12. Accounting and Appropriation Data (If required)
 PROJECT TITLE AND LOCATION: Construct Baghouse, Eielson AFB, Alaska

DACA85-02-R-0023 – AMENDMENT 0004 (11/27/02)
Answers to Proposal Questions
CHPP Baghouse Project
Eielson AFB, Alaska

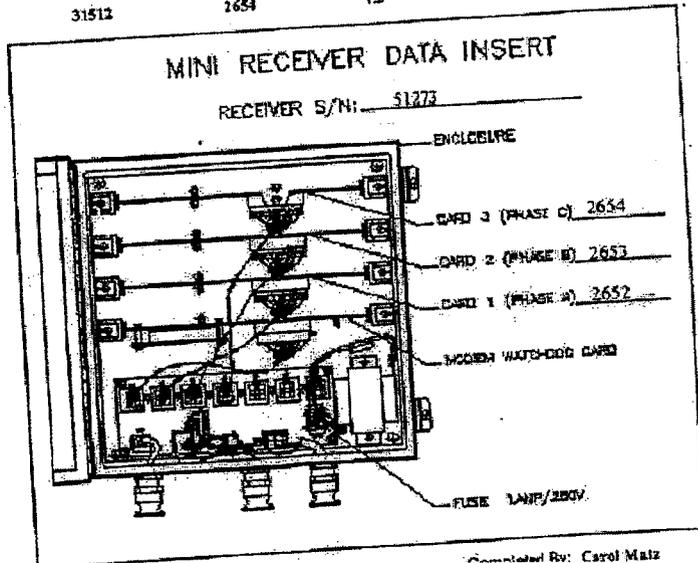
31. On Drawing E3.1, relocation of receiver modules is noted - Can we have existing design drawings for this panel?

See below. Information should be confirmed through site investigation.

Receiver Box # : 51273	Modem # : 4999		
Model : 0351-001	Model : 0413-001		
Revision : B	Revision : B		
Connector Board # : 7229	Watchdog # : 3108		
Model : 0385-001	Model : 0393-001		
Receiver Card #	Receiver Card Pic #	Pic Version #	Eprom Version #
31510	2652	1.2	2.1
31511	2653	1.2	2.2
31512	2654	1.2	2.2
